DEVELOPMENT REVIEW COMMITTEE (DRC) COMMENT REPORT

PROJECT NAME: First Presbyterian Church Parking Lot

CASE NUMBER: R19042

REQUEST: Site Plan Level II Review: 88-Space Parking
Facility

Site Plan:

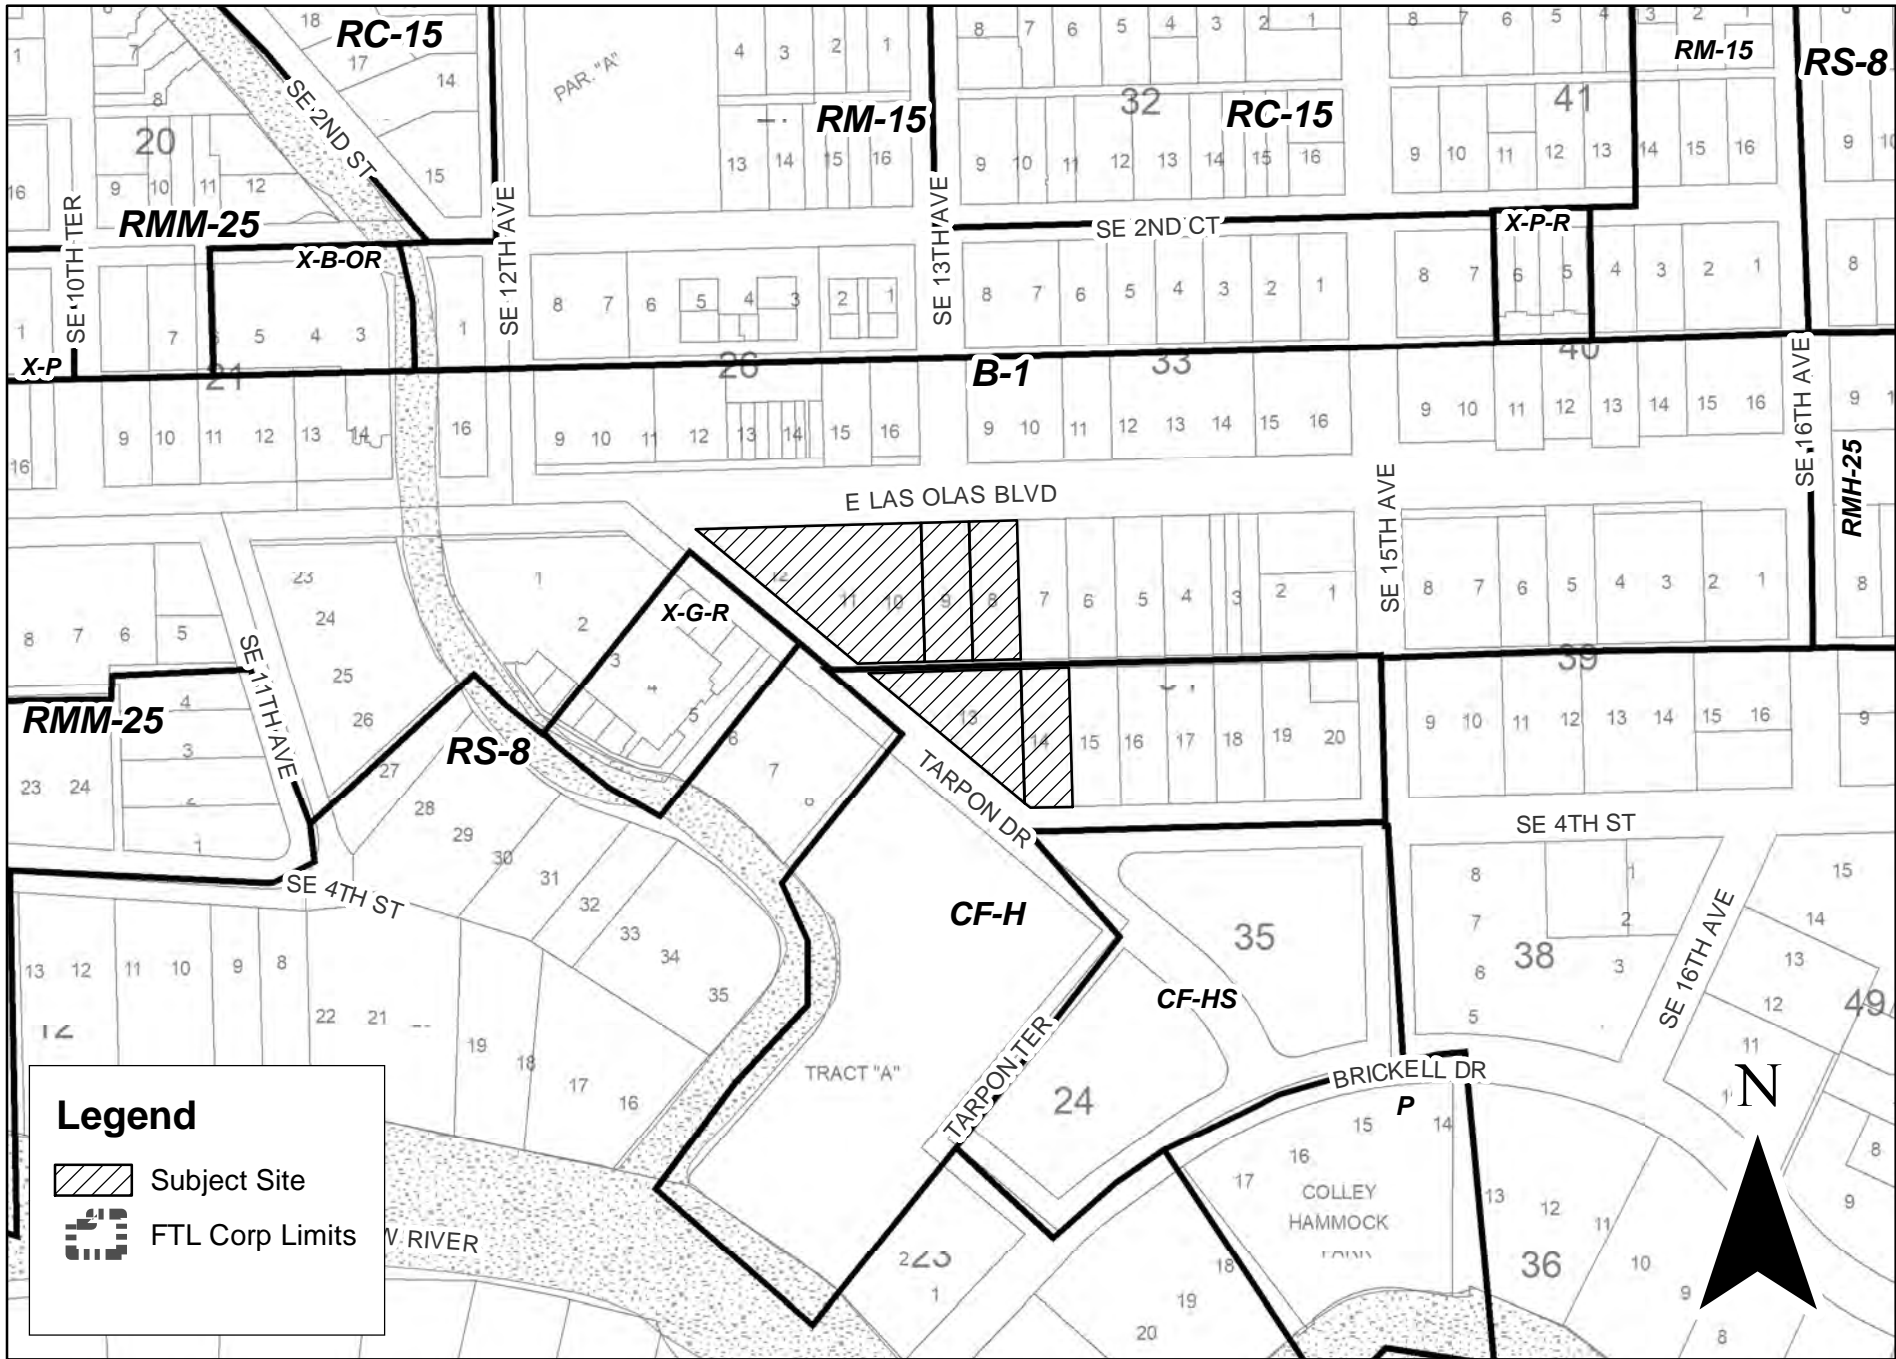
- a. Pursuant to ULDR, Section 47-25.2.M.6. Adequacy requirements/Transportation/Pedestrian facilities: Sidewalks, pedestrian crossing and other pedestrian facilities shall be provided to

encourage safe and adequate pedestrian movement on-site and along roadways to adjacent properties;

- b. Label all proposed pedestrian access/circulation areas: sidewalks, paths, crosswalks etc. (including width) to/from and within the site;
- c. Site plan design indicates pedestrian/vehicle conflict areas. Accommodate safe pedestrian access, in particular to/from public sidewalks, vehicle parking areas and building entrances;
- d. Provide bicycle parking in visible, well-lit areas as close as possible to pedestrian entryways/doors. In addition where possible, locate bicycle parking facilities in an area that is sheltered/covered; and,
- e. Consult the Association of Pedestrian and Bicycle Professionals [APBP] for Bicycle Parking Guidelines and Broward County End-of-Trip Bicycle Facilities Guide at <http://www.apbp.org/>. For more information on bicycle parking standards, please email Benjamin Restrepo at brestrepo@fortlauderdale.gov.
